7/21/21	<span style="color:red">6</span> Added Removal of Existing Delineators
7/14/21	<span style="color:red">4</span> Added Clear & Grub Limits
DATE	REVISION
STATE OF HAWAII DEPARTMENT OF TRANSPORTATION HIGHWAYS DIVISION	
<b>DEMOLITION AND EROSION CONTROL</b>	
<b>INTERSTATE ROUTE H-1 RESURFACING</b>	
Miller Pedestrian Overpass to Kapiolani Interchange	
Federal-Aid Project No. NH-HI-1(279)	
Scale: 1" = 40'	
Date: August 2021	
SHEET No. EC4 OF 23 SHEETS

<b>DEMOLITION AND EROSION CONTROL</b>	
INTERSTATE ROUTE H-1 RESURFACING	
Miller Pedestrian Overpass to Kapiolani Interchange	
Federal-Aid Project No. NH-HI-1(279)	
Scale: 1" = 40'	
Date: August 2021	
SIGNATURE	04/30/22
EXPIRATION DATE OF THE LICENSE	
SHEET No. EC7 OF 23 SHEETS

DEMOLITION AND EROSION CONTROL	
<u>INTERSTATE ROUTE H-1 RESURFACING</u>	
<u>Miller Pedestrian Overpass to Kapiolani Interchange</u>	
Federal-Aid Project No. NH-HI-1(279)	Date: August 2021
Scale: 1" = 40'	
SHEET No. EC8 OF 23 SHEETS

SHEET No. M24 OF 34 SHEETS

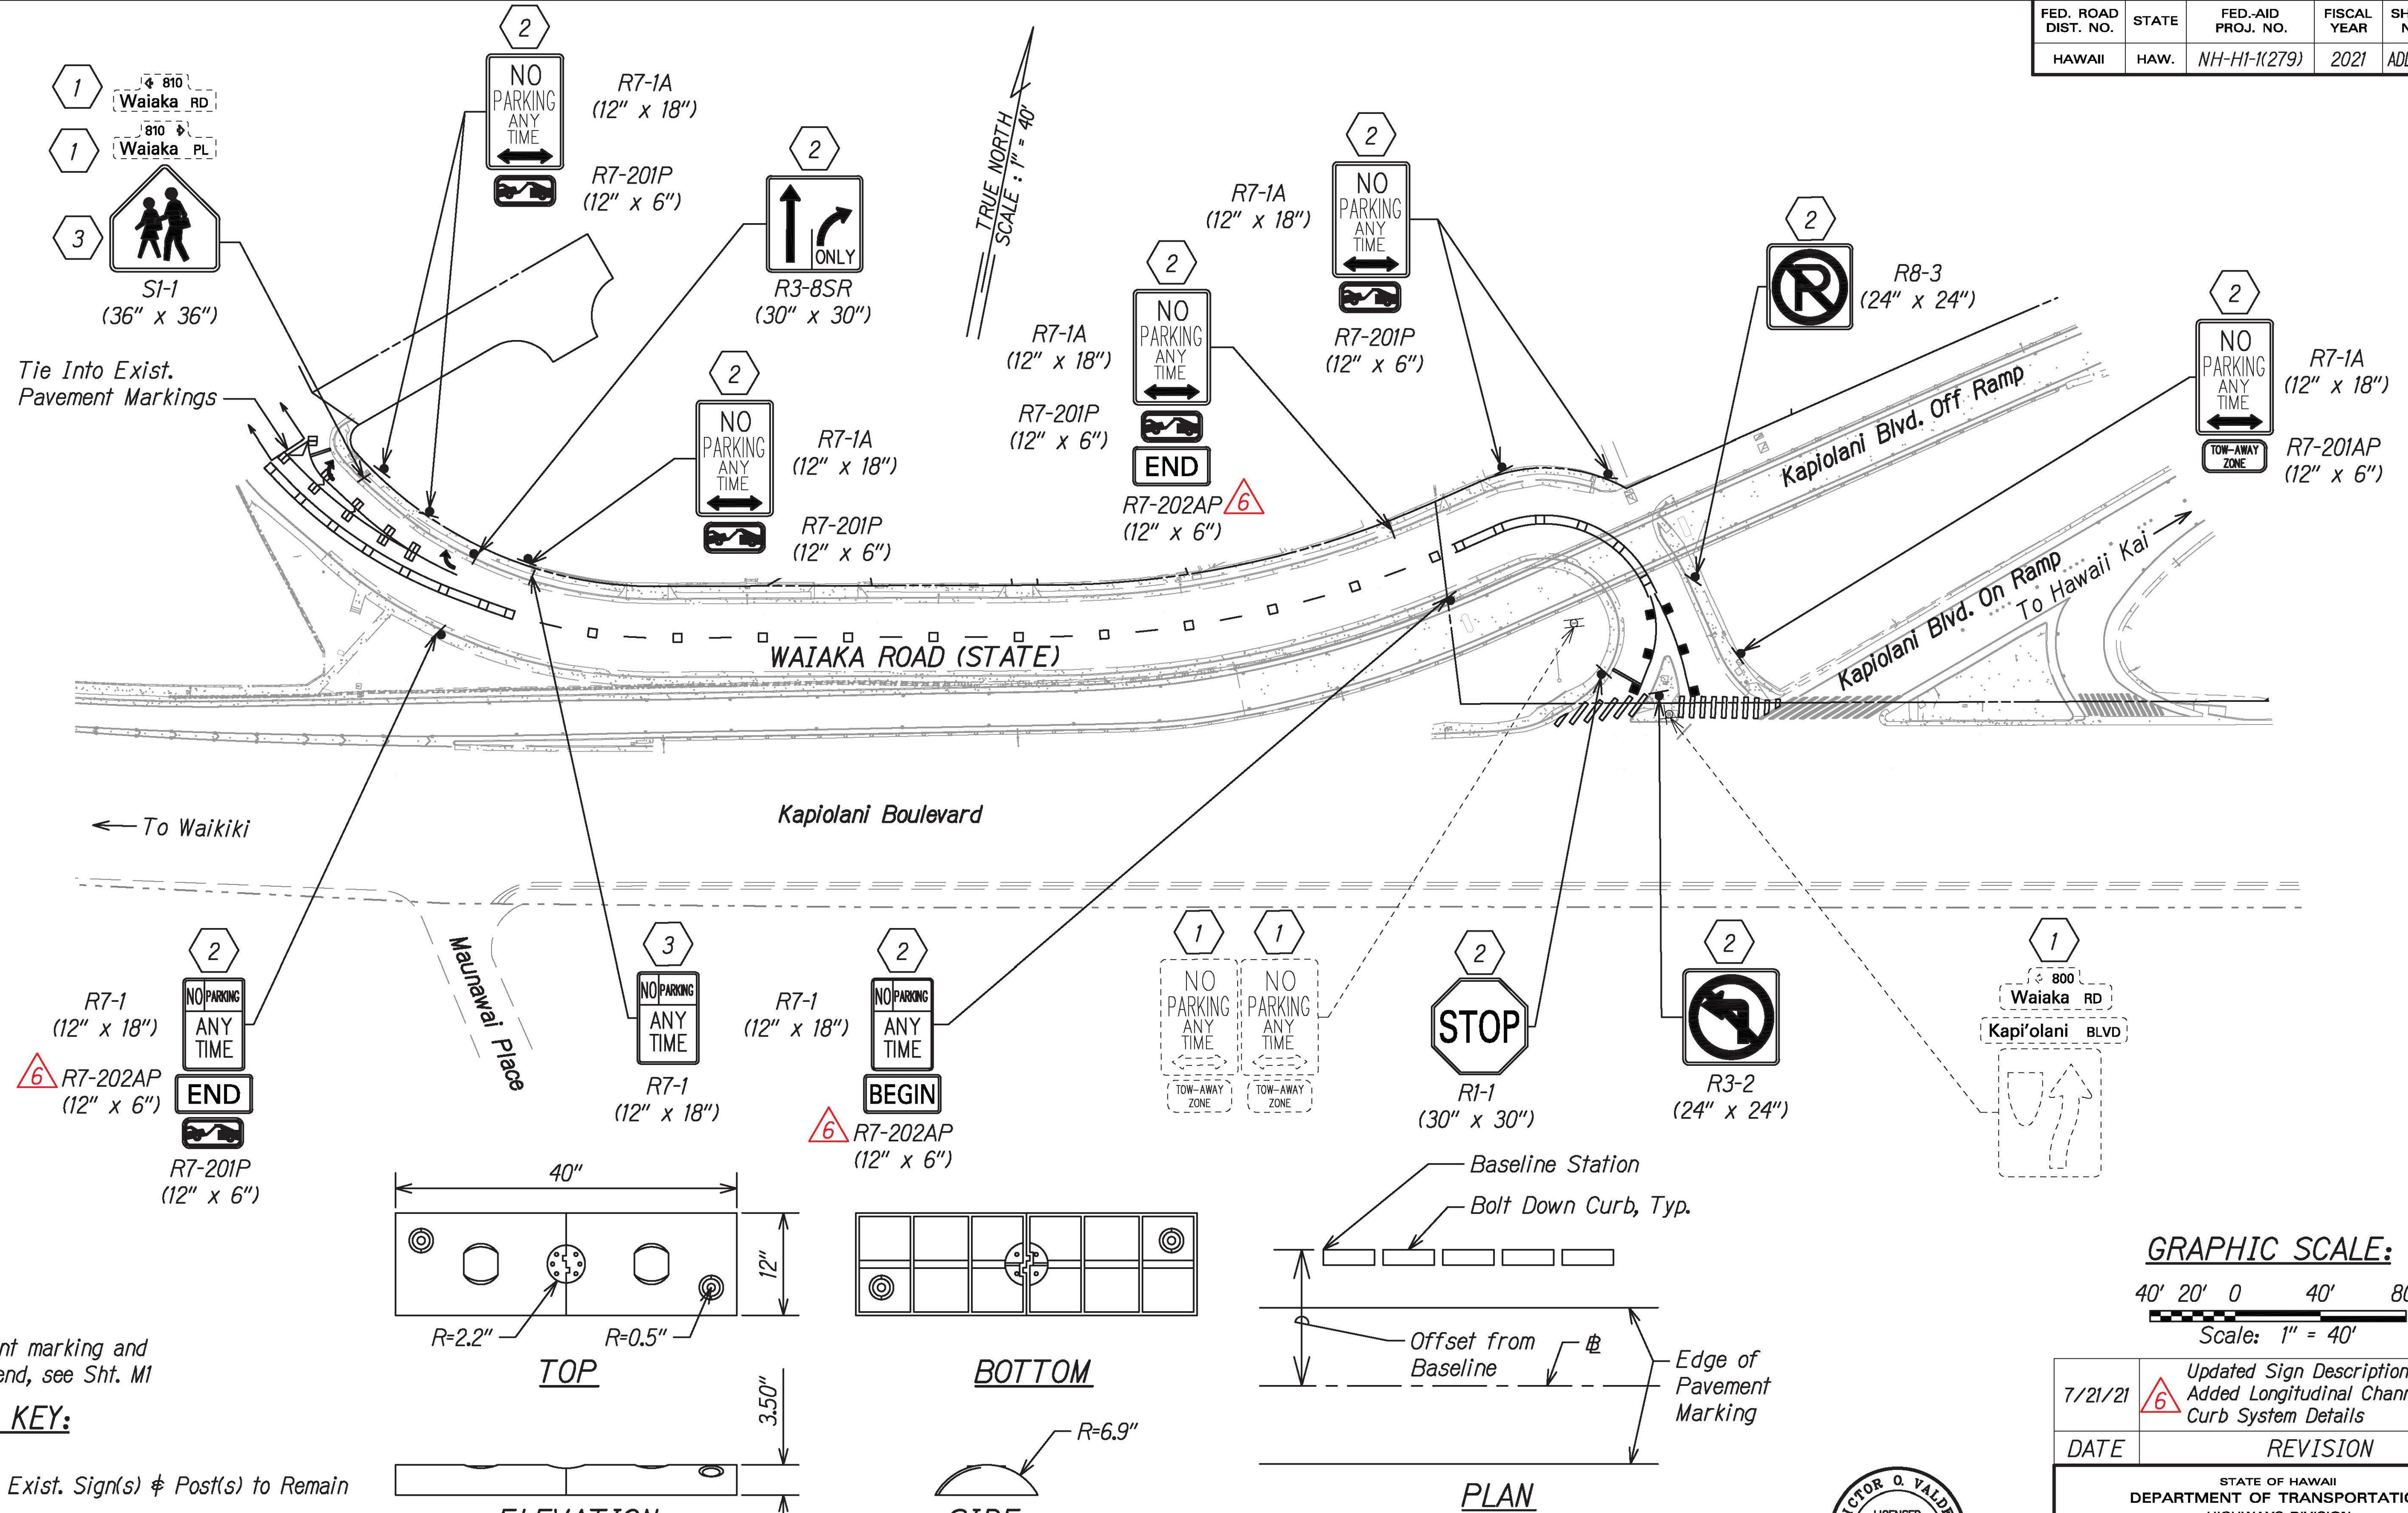
DATE	REVISION
7/21/21	Updated Sign Description and Added Longitudinal Channelizing Curb System Details
STATE OF HAWAII DEPARTMENT OF TRANSPORTATION HIGHWAYS DIVISION	
<b>PAVEMENT MARKING &amp; SIGNING PLAN</b>	
INTERSTATE ROUTE H-1 RESURFACING	
Miller Pedestrian Overpass to Kapiolani Interchange	
Federal-Aid Project No. NH-HI-1(279)	
Scale: 1" = 40'	
Date: August 2021
